# **Ordinary Meeting of Council**

**16 December 2020**

ITEM 9.3            MODIFIED DEVELOPMENT APPLICATION - 1-2018.A -  
ENTERTAINMENT FACILITY - CINEMA COMPLEX -  
MODIFICATION TO UPGRADE FIRE SERVICES AND  
CONSEQUENT LOSS OF CARPARKING - 30 MORISSET  
STREET, QUEANBEYAN.

ATTACHMENT 1    DA 1-2018.A - SECTION 4.55(2) ASSESSMENT REPORT

**Figure 2 - Amended Site Plan**

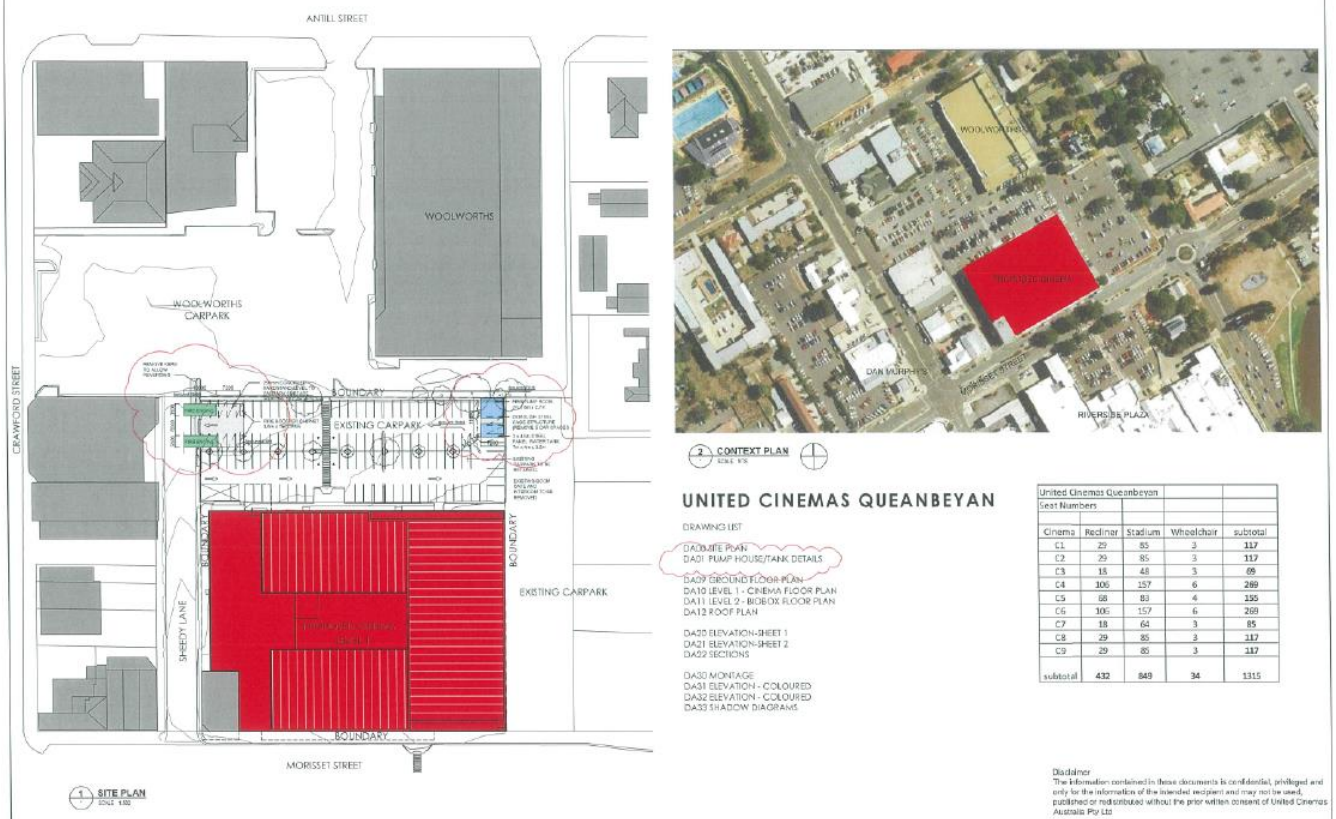
Regarding subclause 'a', it is considered that the modification(s) sought as part of this application are of a minimal environmental impact. Despite the reduction in car parking by 11 spaces (16 with increased widths required as a condition of consent for fire truck parking), it is not considered that this will cause a substantial environmental impact on the site and surrounding uses. Surrounding public parking is underutilised and available for use by cinema patrons. Additionally, the traffic impact assessment has identified that adjoining uses are inconsistent with the peak hours of the use associated with this development.

Figure 4 - Detailed Car Parking Plan

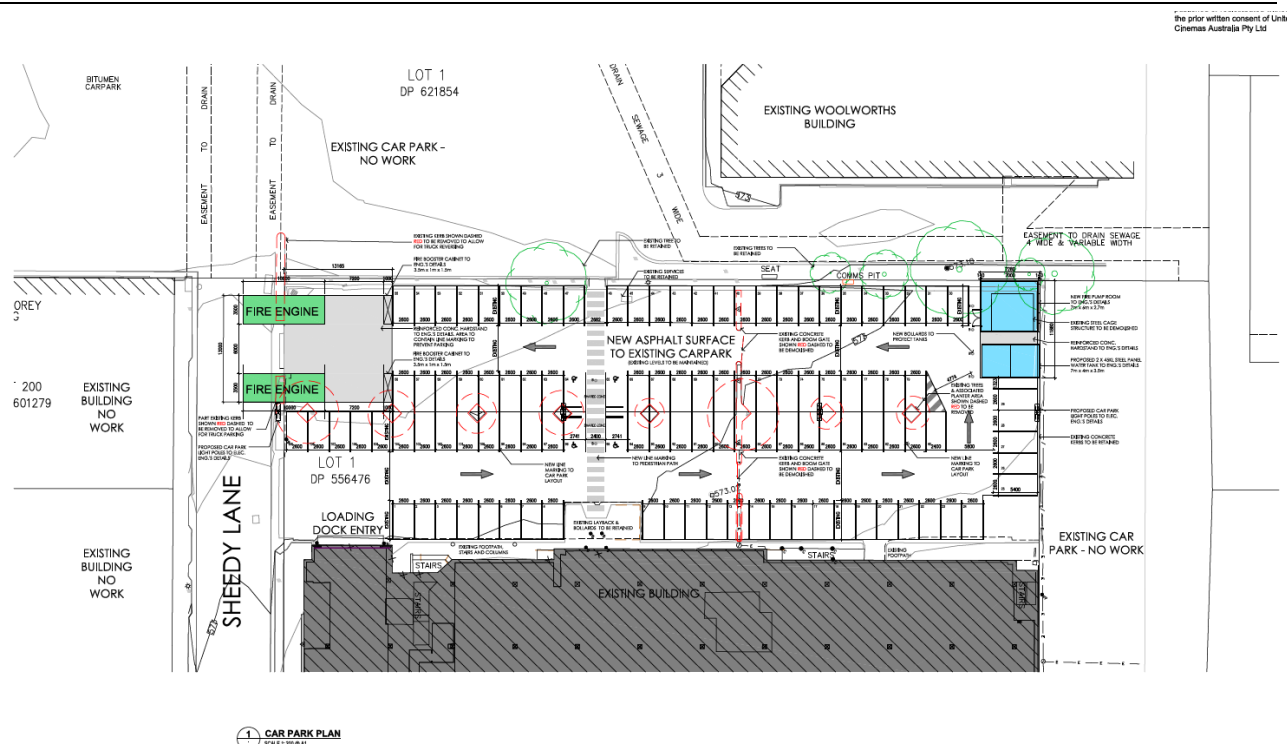
The submitted car park plan indicates the car park fall 8 spaces short of the conditioned 117 spaces of the original development consent. With reference to Table 1.1, the spaces have indicate to be 2.6m consistent with requirement of User Class 3, rather than wider rather than 2.7m wide spaces consistent with user Class 3A which are used for short term high turnover parking in shopping centres. To increase the width of the spaces, one space will be lost from each row of spaces (4 in total).

Further, the fire engine bays only have an apron width of approx. 5.5m which is insufficient for the fire engines to turn into the bays. Swept paths from the Fire Safety Guideline – Access for Fire Brigade Vehicles and firefighters indicates a turn radius of at least 6.5m, thus an apron width to of at least approx. 9m would be required. This will result in a further loss of 4 spaces to shift the fire engine spaces & hardstand area.

Therefore, the total additional loss of parking spaces beyond approved is 15 spaces. Payment for car park contributions for the loss of spaces should be pursued.

***Image 2 – Portion of Internal Driveway to be Converted to Four Parking Spaces***

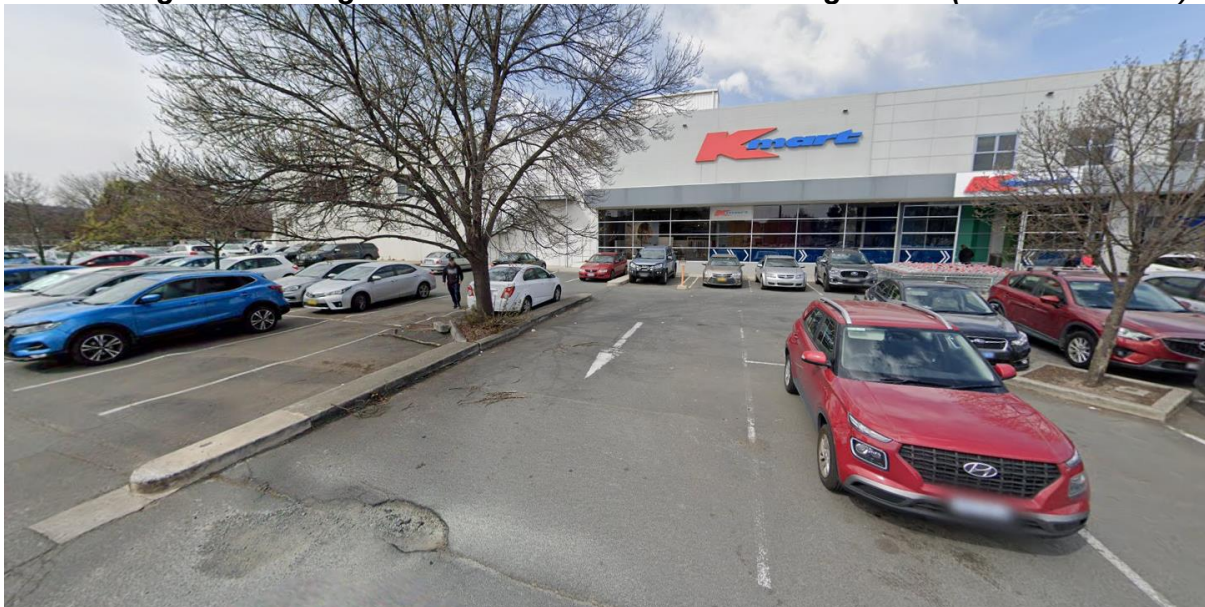
However, the additional 4 car parking spaces to be provided for the site in the location shown in the above image is considered acceptable. The car park will retain adequate manoeuvrability despite the change. Council's Development Engineer has reviewed the dimensions and turning circles associated with these newly created parking spaces and
